Subject: Request to Withdraw and Resubmit a Class 1 Permit Modification Request to the Los Alamos National Laboratory (LANL) Hazardous Waste Facility Permit, EPA ID No. NM0890010515

**Class 1 Permit Modification Request Addition of a Structure within Technical Area
55, Outdoor Storage Pad**

**Los Alamos National Laboratory Hazardous Waste Facility Permit
August 2012**

Class 1 Permit Modification Request Addition of a Structure to Technical Area 55, Outdoor Storage Pad

Figure 10
Technical Area (TA) 55 Location Map Showing Security Fences, Entry Gates, and Entry Stations

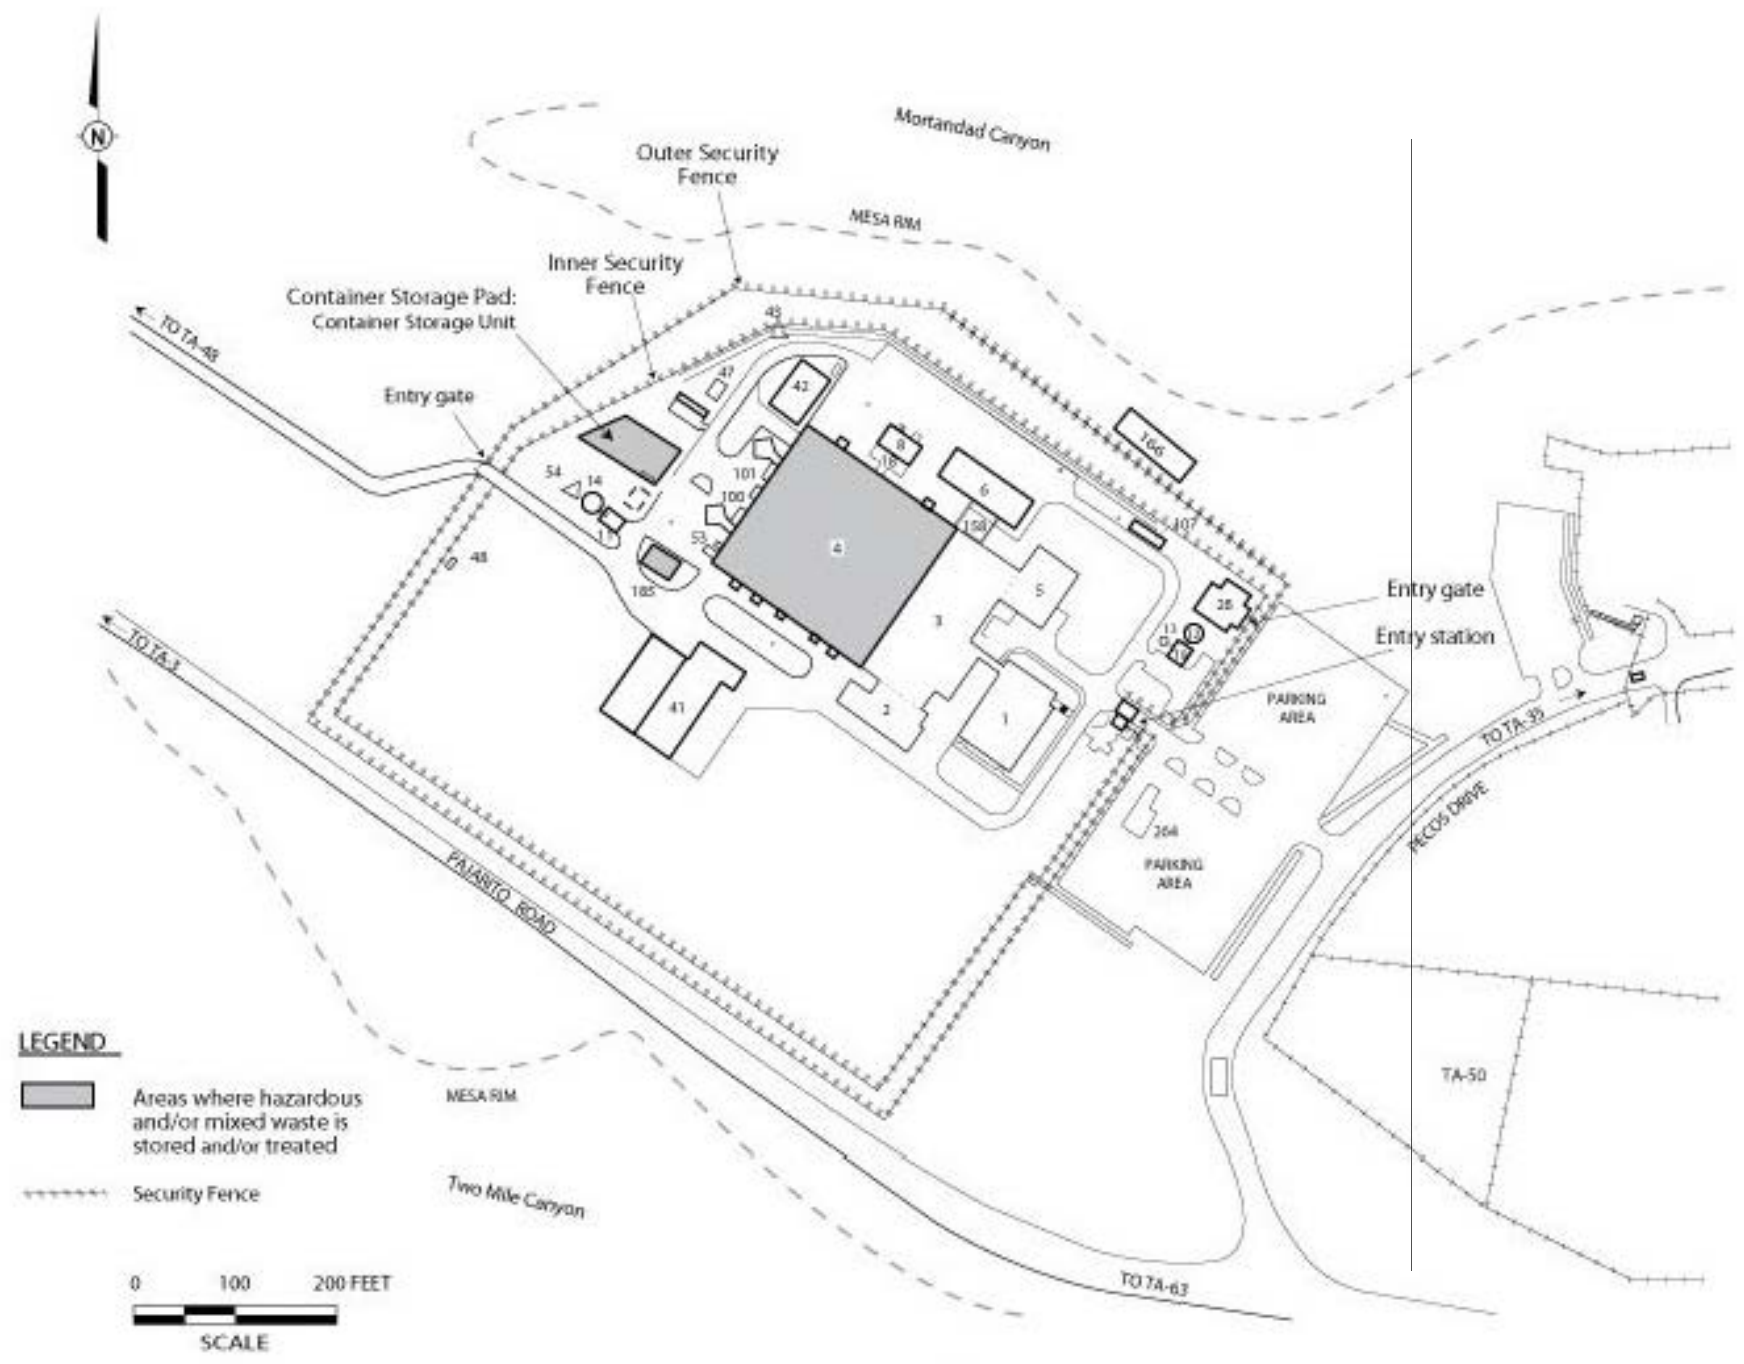
Descriptions of the structures have been added to Section A.5.6 of Attachment A, *TA – Unit Descriptions*; Sections 2.0 and 5.2.2 of Attachment G.26, *Technical Area 55 Outdoor Storage Pad Closure Plan*; and Table J-1 of Attachment J, *Hazardous Waste Management Units*. Revised figures are Figures 10, 39, and 45 of Attachment N, *Figures*; and Figure G.26-1 of Attachment G.26, *Technical Area 55 Outdoor Storage Pad Closure Plan*.

Figure 45
 Technical Area (TA)-55, Building 4, Outdoor Container Storage Pad

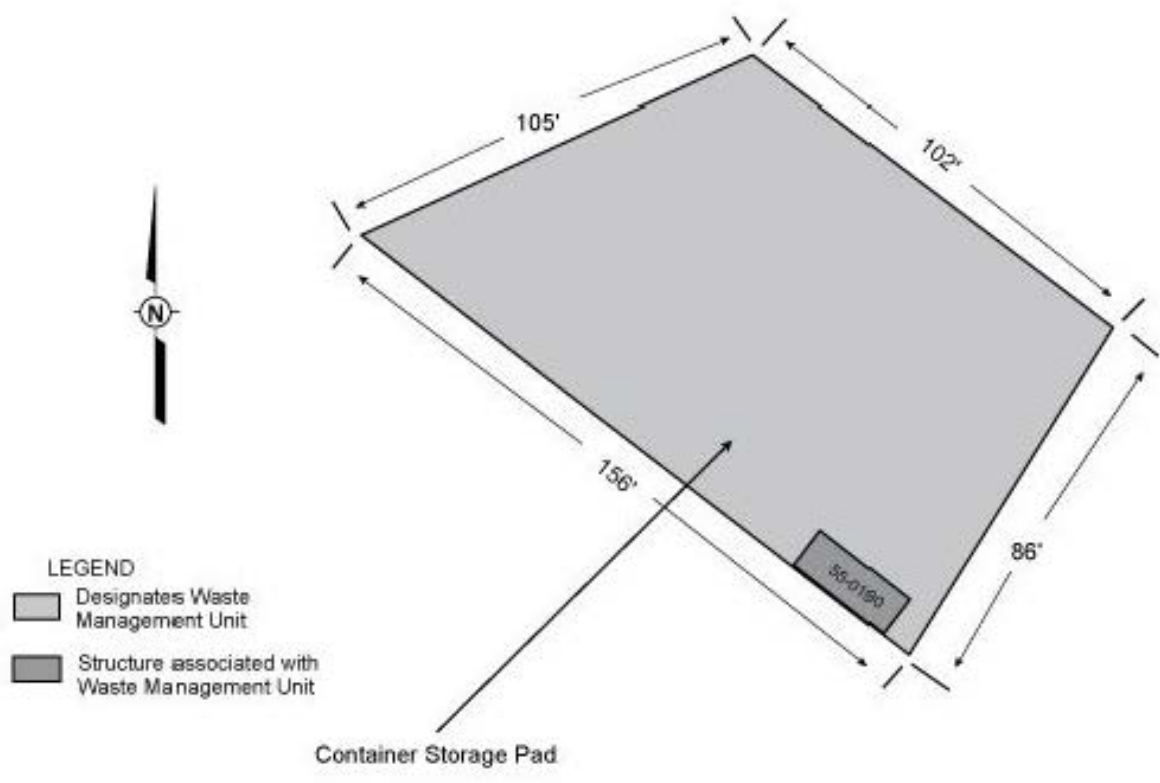
Waste containment storage building TA-55-PF-190 is located on the south-eastern portion of the Container Storage Pad and is used for storage of hazardous waste. It measures approximately 22 feet long and 8 feet 4 inches wide (see Figure 45 in Attachment N (*Figures*)). The building is a manufactured steel building that is designed for hazardous waste storage.
